## LINCOLN CITY/LANCASTER COUNTY PLANNING STAFF REPORT

for October 12, 2005 PLANNING COMMISSION MEETING

**PROJECT #:** Change of Zone #05067

**PROPOSAL:** Change from R-6 Residential to B-4 Lincoln Center Business

B-4 SETBACKS W/O ACQUISITION OF ADJL PROPERTY

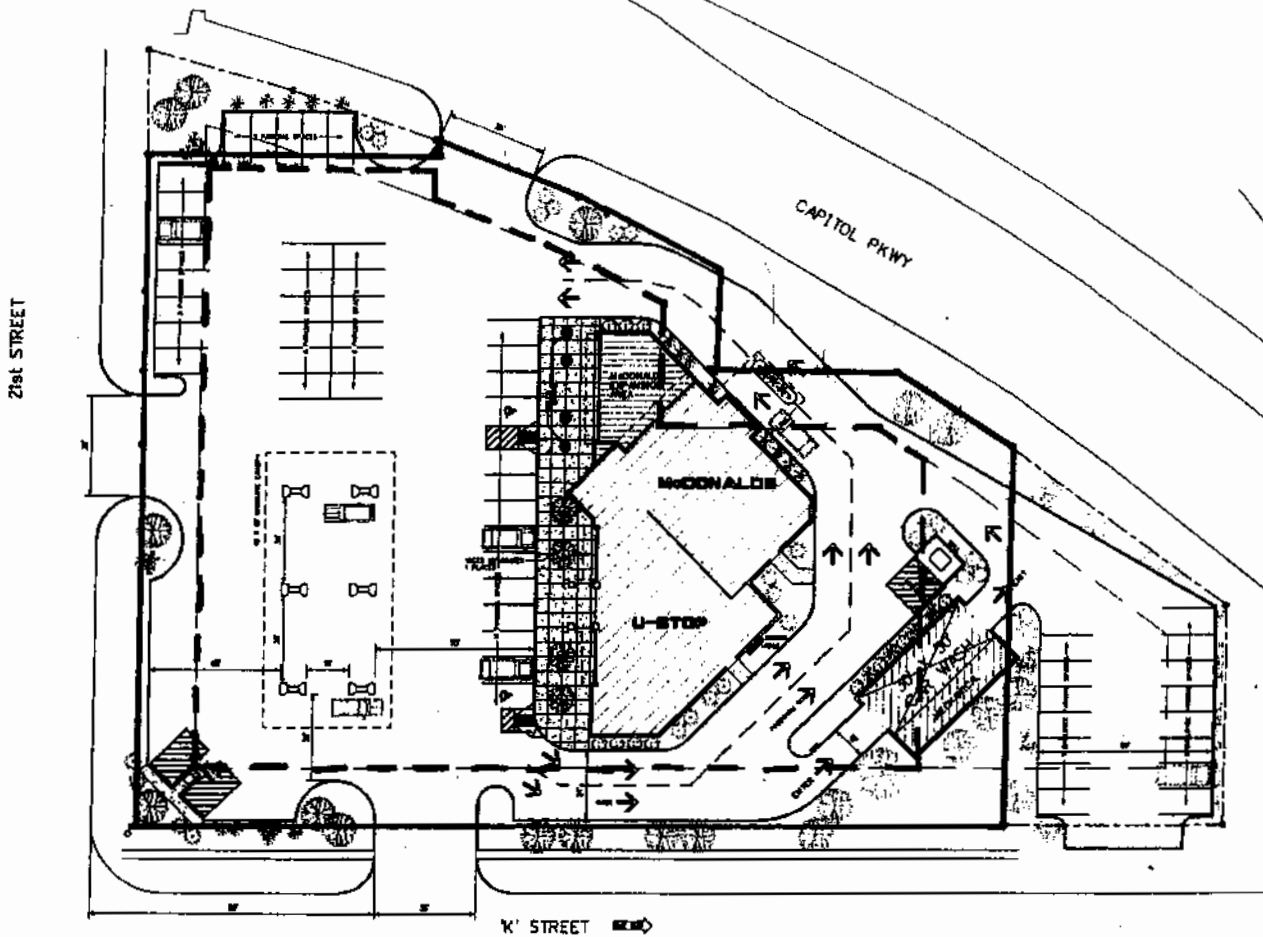
7. The proposed site plan shows 15 parking spaces in two rows and a portion of the car wash building located at the east end of the property within abandoned 22<sup>nd</sup> Street right-of-way. This vacated right-of-way is still owned by the City. This is also in the location of a potential access to "K" Street, as indicated by Public Works. This parcel must be purchased from the City if it is to be used for this development. Also, portions of the drive-thru and pass-thru lanes for the fast food restaurant are shown in the public right-of-way, and must be removed.

8. Three sides of this parcel abut public right-of-way and must provide a 20' front yard setback. The fourth side must provide a 30' rear yard setback. Accessory structures may not occupy more than 30% of the required rear yard, and parking is not allowed within the required front yard. Based solely on Applicant's current ownership, portions of the fast food restaurant, the drive-thru lane, the car wash building, the vacuum station, and many of the parking spaces are located within required setbacks. Assuming the necessary right-of-way and vacated right-of-way is purchased, the vacuum station and a number of parking spaces will continue to be located within required setbacks. The percentage to which the accessory car wash building covers the rear yard is unknown.

- 1.1.1 Conforming to the required setbacks.
  - 1.1.2 Showing access to "K," "L," and 21<sup>st</sup> Streets to the satisfaction of the Public Works Department.

- 1.1.3 Showing ownership of vacated 22<sup>nd</sup> Street , the notch in "L" Street right-of-way, and the two portions of lots owned by the City, or revise the access, parking layout, and setbacks to the satisfaction of the Public Works and Planning Departments.

**U-STOP FRONT ELEVATION**

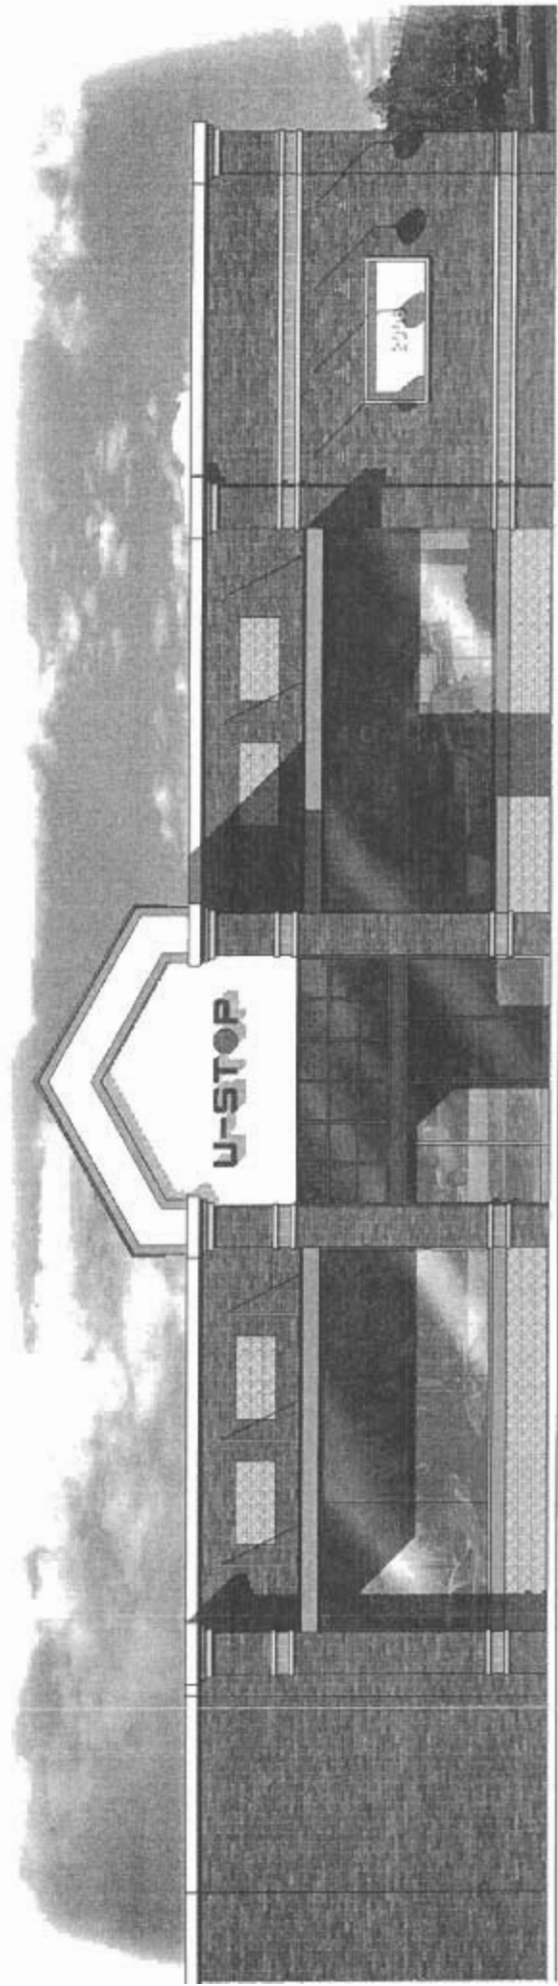
4. Plans for the area also address architectural design and detail as it relates to the existing character. A typical, modern, combined convenience/gas/fast food/car wash establishment does not blend well into an area such as this, which is characterized by traditional materials and reduced setbacks.

- Primary material on all facades of main building, not including glass area, must be non-painted red or brown face brick. All structures on the site must have consistent architectural detailing and design elements. All accessory building walls, screening walls, and canopy columns must use the same primary material, color and detailing as on the main building. Secondary building colors must be white or earth tones.
- West-facing facade shall be substantially as depicted in submitted elevation drawing (which we hope to work out with them as being more "traditional" with gabled entry feature, glass areas more articulated, no racing stripes, etc.)
- Overall height of canopy must not exceed 17 feet. The depth of canopy fascias (sides) must not exceed 3 feet, and must extend at least 12 inches below the ceiling to block view of the light sources.
